2. Wilderness Edge Subdivision; KPB File 2026-002

Peninsula Surveying / Lucas, Hewitt-Lucas

ITEM #2 - PRELIMINARY PLAT
WILDERNESS EDGE SUBDIVISION

STAFF REPORT

PLAT OF
WILDERNESS EDGE SUBDIVISION

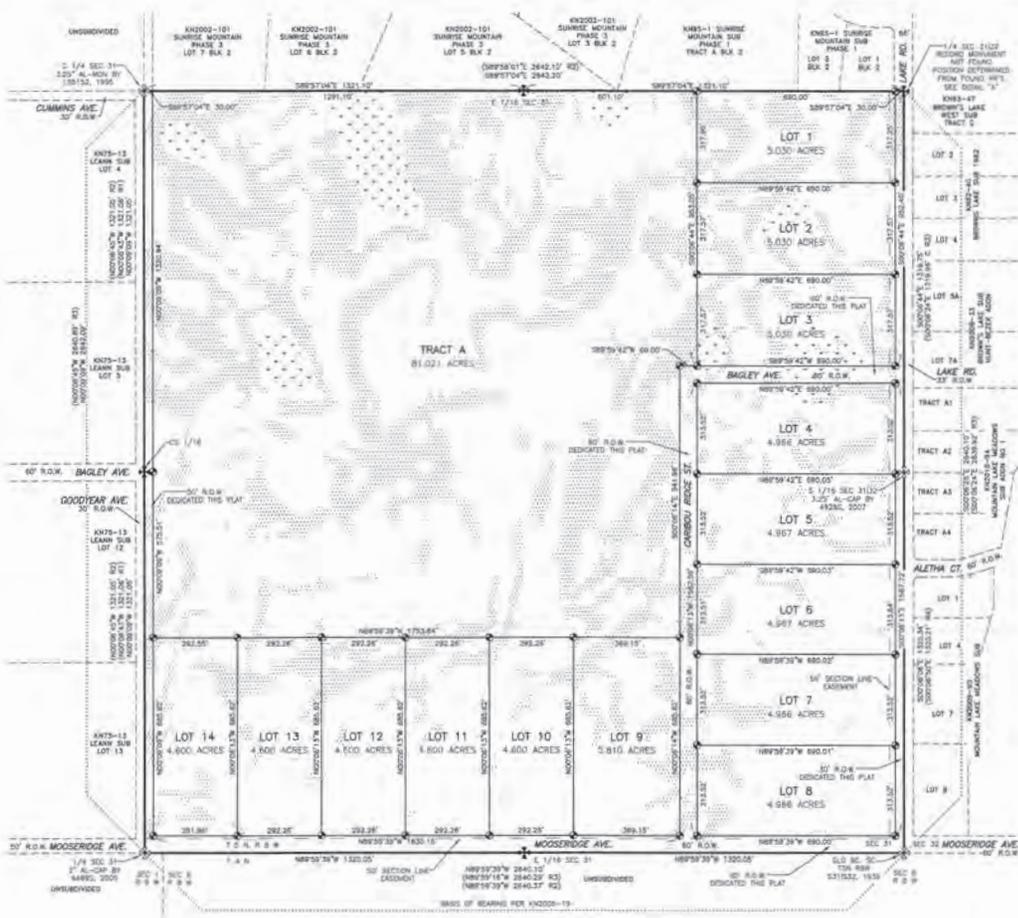
On the interior of the plat is proposed two 60' dedications to be know as Caribou Ridge St coming from the Moose Ridge Ave and Bagley Ave coming from Lake Rd. The addressing Officer has noted that Bagley Ave is not lined up with the existing Bagley Ave to the west and should choose a new name. Caribou Ridge is using prohibited street names and needs new. **Staff recommends** the surveyor contact the Addressing Officer for new names for these two dedications.

The plat is affected by section line easement on the south and east side of the plat. **Staff recommends** the surveyor verify the SLE size with documentation and supply to staff and correctly show on the drawing and identify in the plat notes.

Block length is not compliant around the plat. The west line of the plat extends 2600 feet along the exterior with Goodyear Ave, with no break point into the plat interior. Bagley Ave is at the half way point along Goodyear Ave to push into the plat for a break in the block. On the north there is no dedication of road proposed to break the block or extend Cummins Ave. The surveyor has requested exceptions to KPB 20.30.170 Block Length- requirements and KPB 20.30.030 Proposed Street Layout for the extension of Cummins Ave and Bagley Ave. These exceptions will be further discussed later in the staff report.

KPB Roads Dept. comments	Out of Jurisdiction: No Roads Director: Uhlin, Dil Comments: Bagley Ave. is named twice in two separate locations on this plat.
SOA DOT&PF comments	No comments

The terrain of the plat is a rough configuration throughout, as can be seen by the contour map in the packet. Areas where the slope is steep and approximately greater than 20% has been shown on the plat drawing. Seeing that the steep slopes are throughout the 160 acres of the plat and showing direction of the downslope would detract from the drawing, **staff recommends** the hatching not be shown on the final.

There are no improvements or structures on the property that are visible on the KPB GIS data. Aerial data does show structures on the lots to the northeast close to the property lines. **Staff recommends** the surveyor note any encroachments to the property and they will be resolved prior to final plat approval.

Per the River Center review the plat is not located in neither a FEMA designated flood hazard area nor a habitat protection district. **Staff recommends** plat note 7 be either removed or modified to state that the plat is not in a FEMA flood hazard area.

Correct typos in street names in the Certificate of Acceptance.

Add the date of February 9, 2026 to the Plat Approval.

Match the Certificate of Ownership and Dedication to that as shown in KPB 20.60.190(A) (5).

Modify KPB File No to 2026-002

Area should be to nearest 100th, staff gets area to 160.140 acres.

Modify the name Moose Ridge Ave along the south of the plat and to the west and east to two words.

Plat note 6 states 33' SLE and the drawing shows 50' SLE, verify correct width and supply documents to staff.

3 Lots north of Lot 1 need the plat label corrected and in the detail.
